## Planning Services Sign Permit Review Form

Date of Submittal	Application Number	Applicant	Landowner
8/07/2020	SIGN2008-0002	Allen Industries	Boddie Noell Enterprises

Contact Person	Contact Number
Heather English	(336) 799-4670
Sign Location	PIN Number
2471 NC 87 S. Cameron	9575-95-4454.000

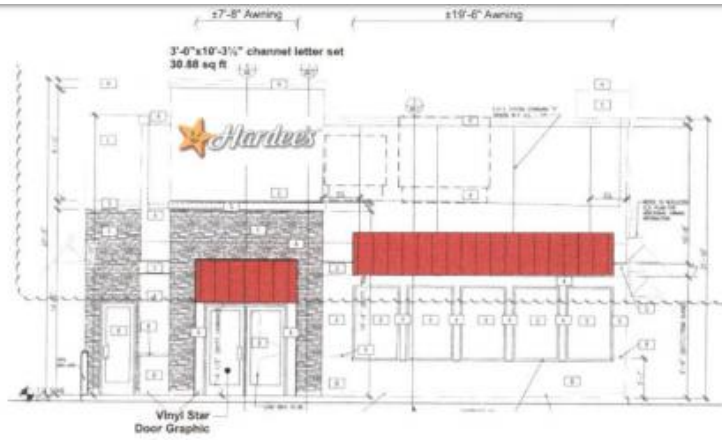
Comments	<ol style="list-style-type: none"> <li>1. Ground sign exceeds maximum height permitted. Please reduce height of ground sign by 2".</li> <li>2. Please label distance of ground sign to the front and side property lines. 20' from each property line is required.</li> <li>3. Please provide size of the vinyl window graphics in square feet.</li> </ol>
----------	--
